System: Aux Feedwater      Location: Aux Feed Pump Room

MR NUMBER 88-099 B/C

Title of Proposed Modification,  
Procedure Change, Test or Experiment Increased Auxiliary Feedwater Pump Mini-Recirc Line Flow Capacity

**NUCLEAR POWER DEPARTMENT  
ENGINEERING CHANGE REQUEST**

TECHNICAL FILE INDEX  
MODIFICATION REQUEST  
HANGER NO. 1157

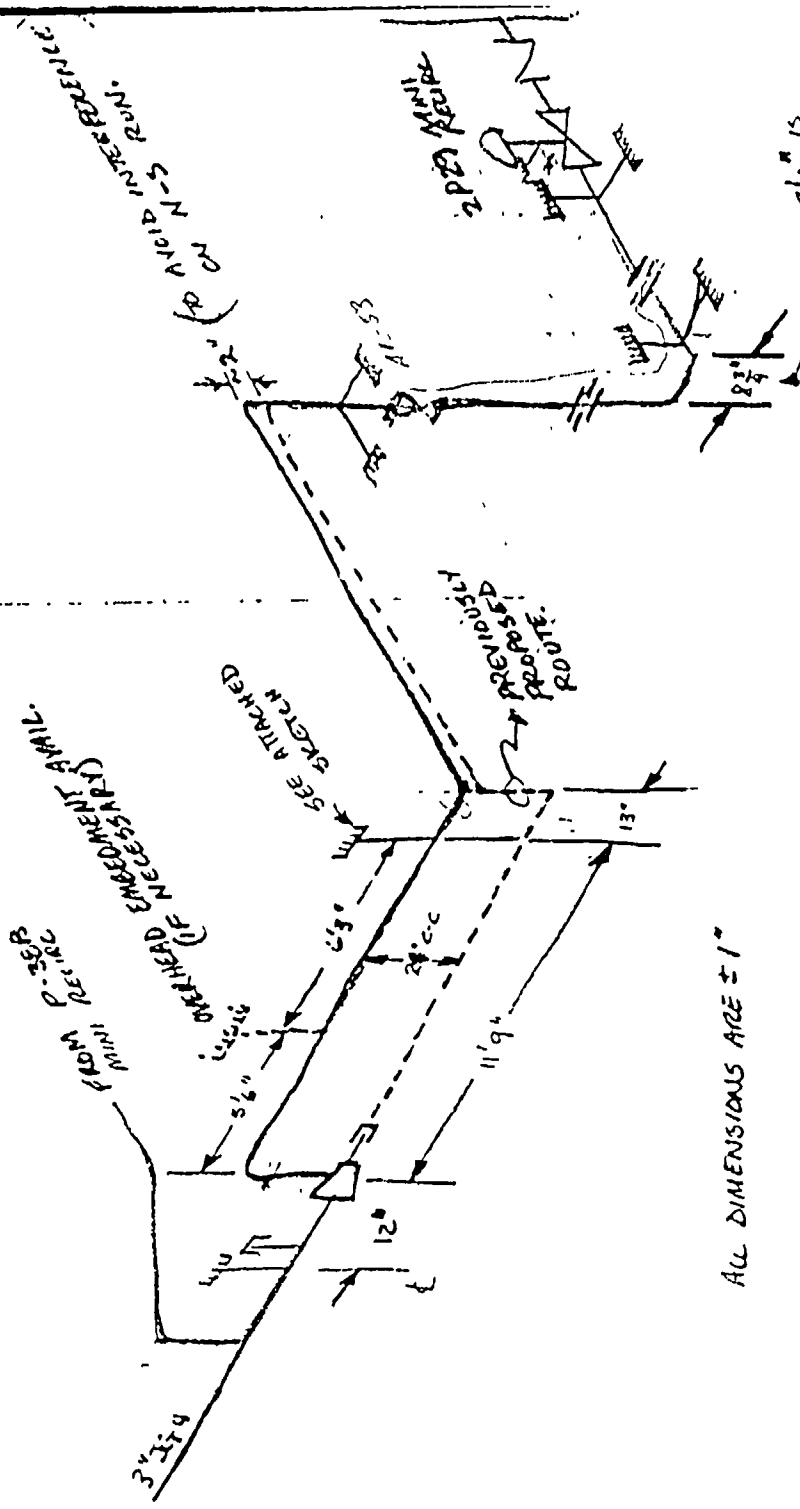
AN EXTRA 3/4" IS REQUESTED TO AVOID POSSIBLE INTERFERENCES IN OVERHEAD (E-W RUN)

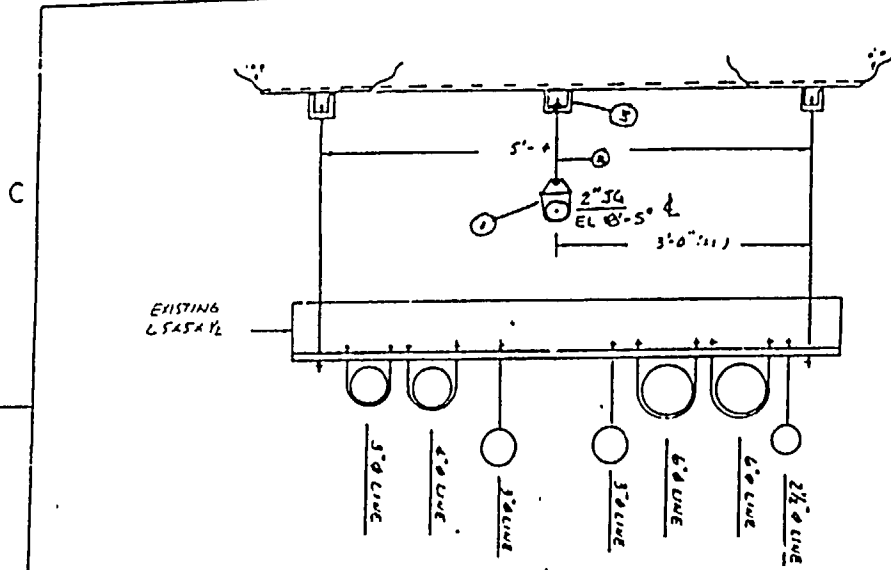
1. A 4" x 2" SOCK-O-LET WILL BE RE-CONTURED TO FIT THE 3" HEADER.
2. CUT EXISTING 1 1/2" PIPE AT THE WELD ON THE COUPLING.
3. A PLUG WILL BE MADE (SEE DETAIL A-A), INSERTED IN SOCKET ON COUPLING, AND SEAL WELDED IN PLACE.
4. EDGE OF PLUG WILL BE BEVELED IN THE FIELD, AS NECESSARY.
5. PLUG TO BE MADE OUT OF 2" ROUND ROD, SS TP. 304L, LOT # 902-8587.
